Service Bulletin

Bulletin No.: 16-NA-147

Subject: Brake Pedal Squeak Noise Heard When Applying and Releasing Brake Pedal

Brand:	Model:	Model Year:		VIN:		Engine:	Transmission:
		from	to	from	to		
Chevrolet	Volt	2016	2017

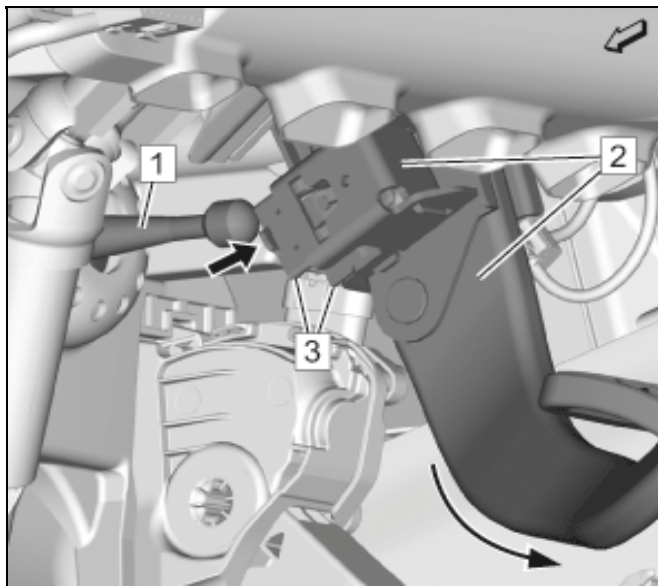
3. Disconnect the brake pedal push rod (1) from the brake pedal (2). Press the two tabs of the brake pedal push rod retainer (3) together and pull the brake pedal to facilitate the removal.

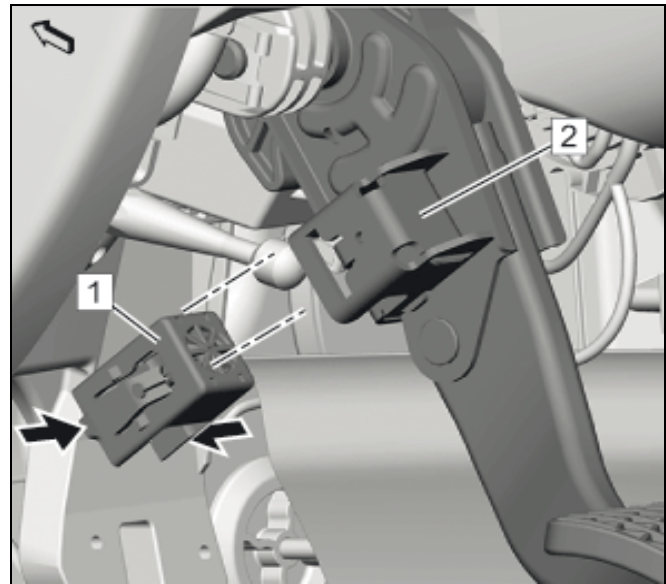
4. Remove and **DISCARD** the brake pedal push rod retainer (1) from the brake pedal (2).
5. Install the **NEW** brake pedal push rod retainer to the brake pedal.
